Project No. 2023-056C

**RE: NOVEMBER 17, 2025 INSPECTION SUMMARY OF THE SHINGLE SPIT BOAT LAUNCH,
HORNBY ISLAND**

Photo 3. Showing excess geotextile cloth along the riprap on the north side of the ramp during the 17-Nov.-2025 site inspection. Note the large gap between the cloth and the edge of the ramp. Rebar shown in this photo should also be removed.

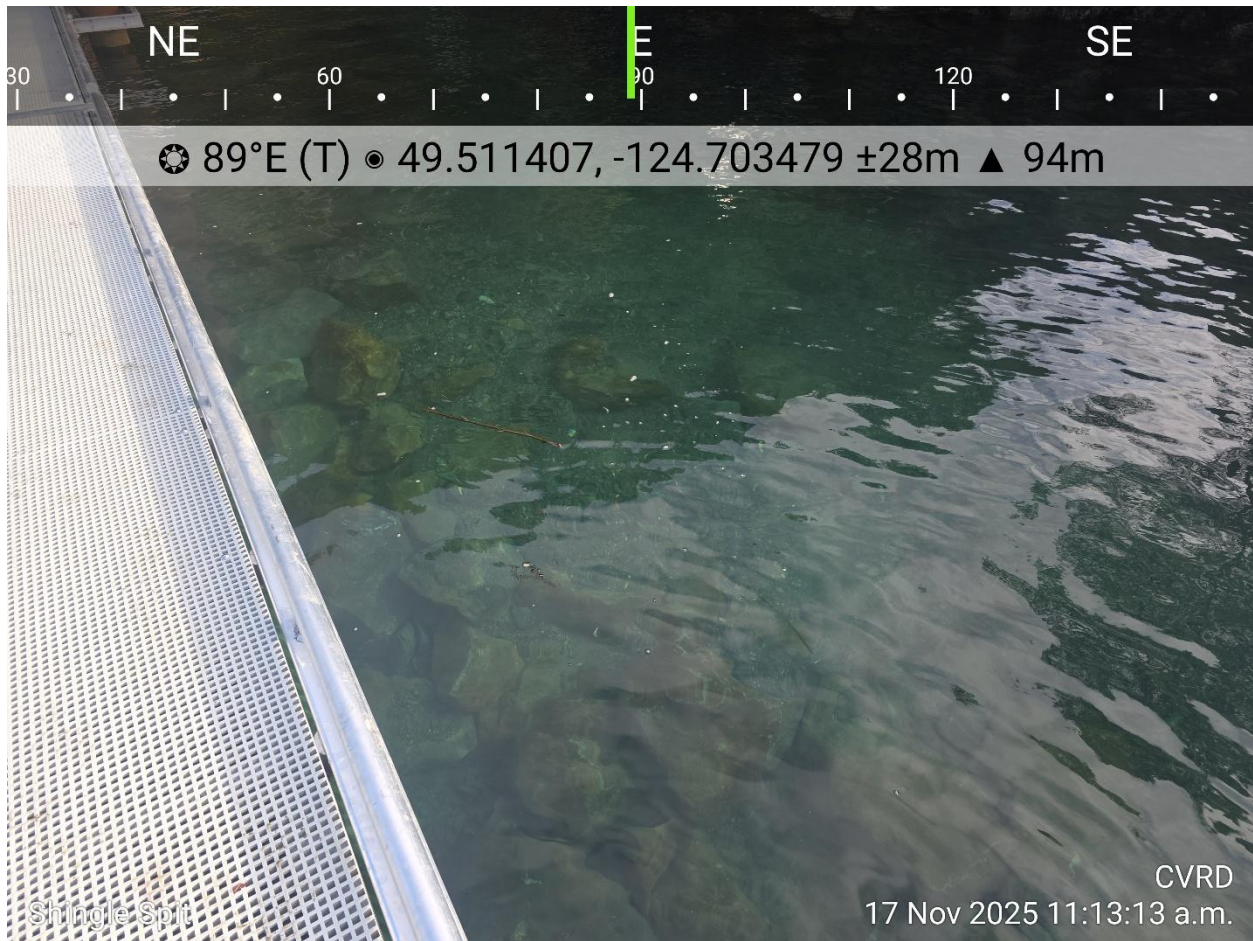
- There is still a lot of geotextile cloth sticking out from around the riprap and a substantial gap between the edge of the riprap and the ramp deck (Photo 2-3). I understand this has also been identified by Cascara. More riprap is required along the margins of the ramp to fill in this gap and completely cover the geotextile cloth. Some combination of trimming and cleaning up excess geotextile cloth may also be required. This was noted along the entire length of the ramp, on both sides.
